SAFETY EVALUATION
FOR REVISING THE SPECIFICATION FOR
UPRATE
VIRGIL C. SUMMER NUCLEAR STATION
TECHNICAL SPECIFICATIONS

South Carolina Electric & Gas Company (SCE&G) proposes to revise the following Virgil C. Summer Nuclear Station (VCSNS) Technical Specifications (TS) pages: 1-5, 3/4 4-31, 3/4 4-32, 3/4.11-5, and 6-16a. These changes support the Uprate project and provide the following:

Figure 3.4-2 V. C. Summer Unit 1 Reactor Coolant System Heatup Limitations (Heat up rates up to 50 and 100°F/hr) Applicable for the First 13 EFPY (With Margins 10°F and 60 psig For Instrumentation Errors)

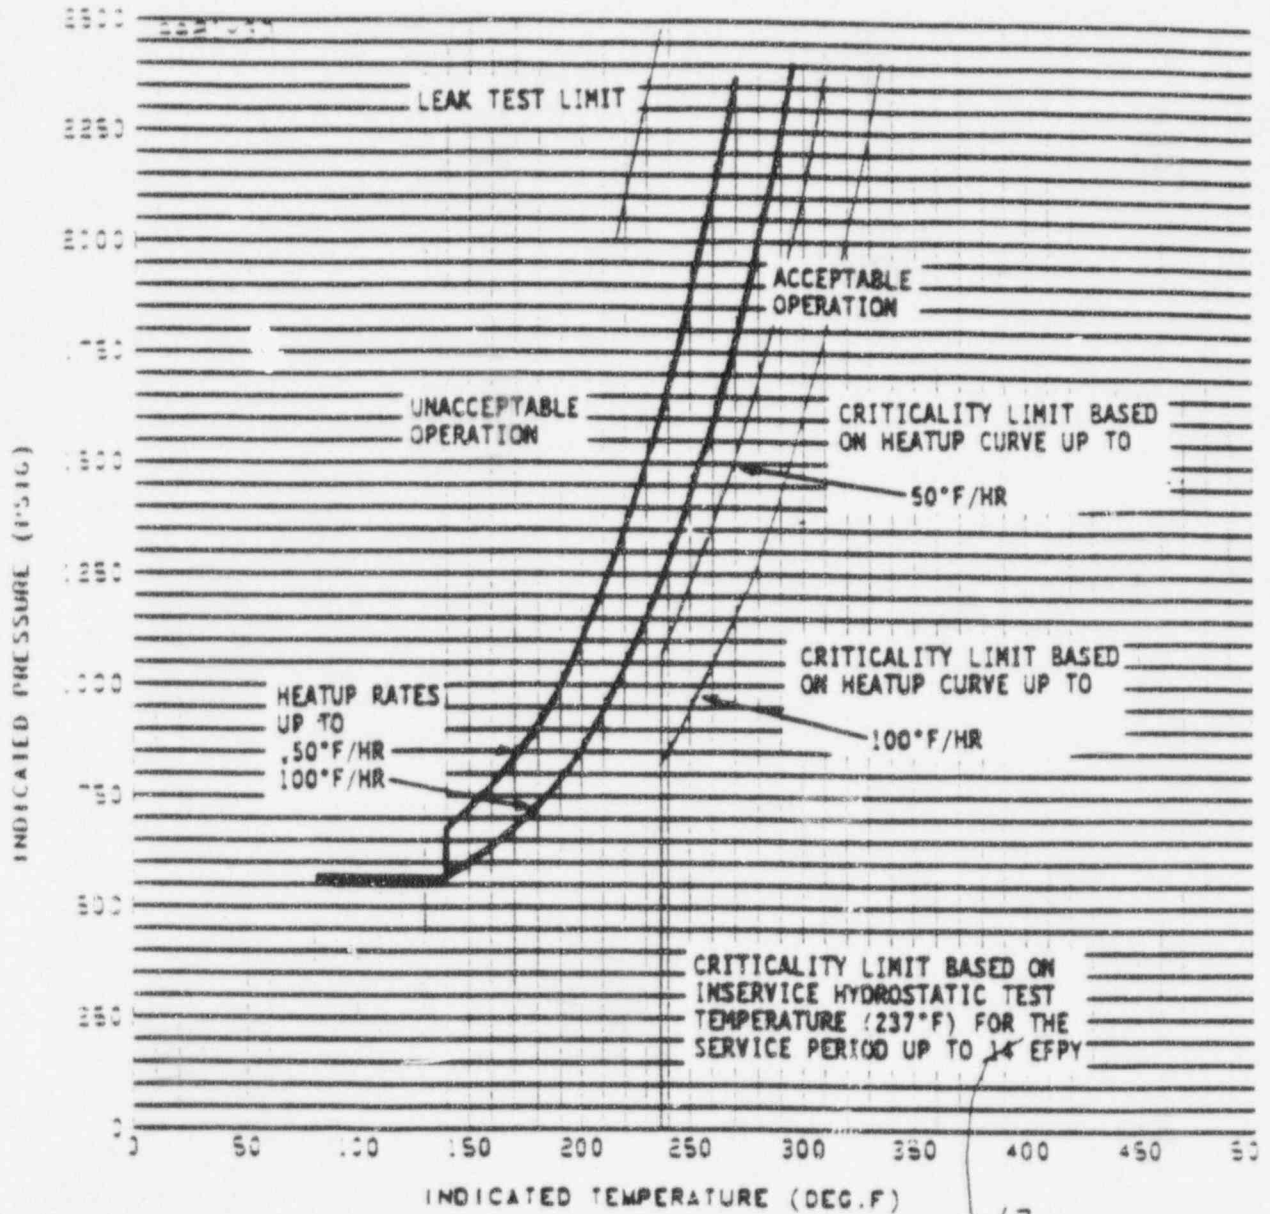
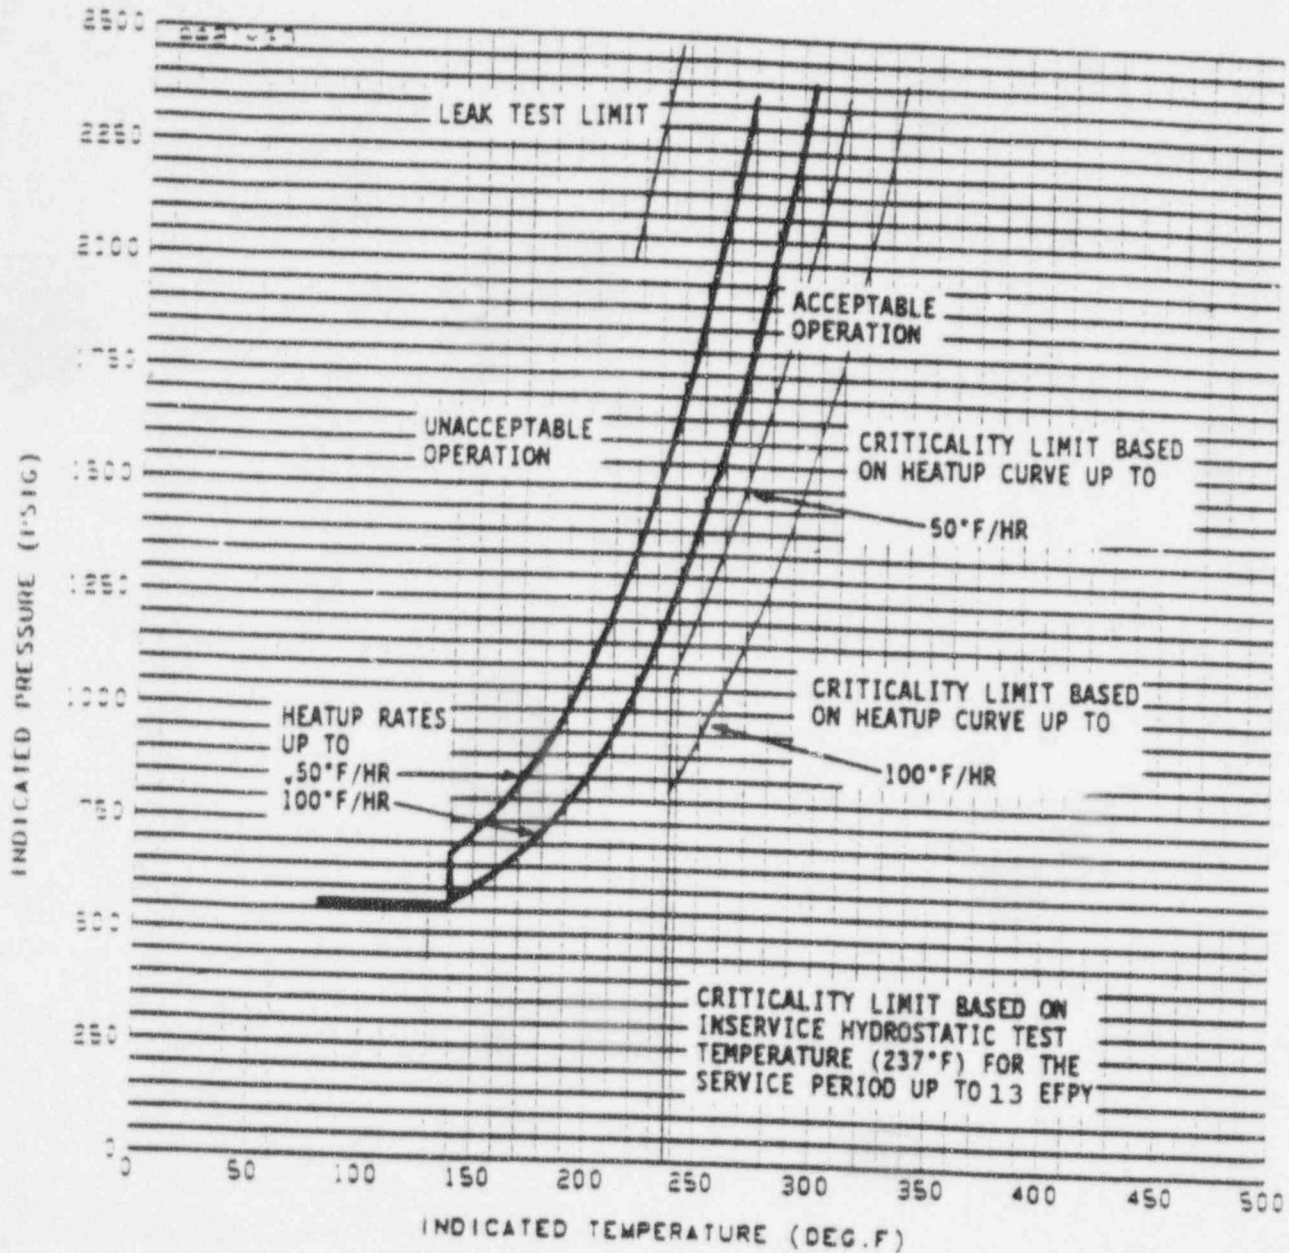
Increased neutron fluence resulting from uprate core conditions has an effect on the reactor vessel Pressure Temperature Curves. Their applicability will change from 14 Effective Full Power Years (EFPY) to 13 EFPY with no other changes at this time.

Increased neutron fluence resulting from uprate core conditions has an effect on the reactor vessel Pressure Temperature Curves. Their applicability will change from 14 Effective Full Power Years (EFPY) to 13 EFPY with no other changes at this time.

The revision to the Pressure Temperature Limits will not adversely impact the RCS Pressure Boundary. The length of time these curves will be applicable, due to increased neutron fluence, is being reduced. Before the 13 Effective Full Power Years have elapsed, new curves will be generated to reflect the analysis of the specimen capsule and will be derived utilizing NRC approved methodology.

Figure 3.4-2 V. C. Summer Unit 1 Reactor Coolant System Heatup Limitations (up rates up to 50 and 100°F/hr) Applicable for the First 14 EFPY (With Margins 10°F and 60 psig For Instrumentation Errors)
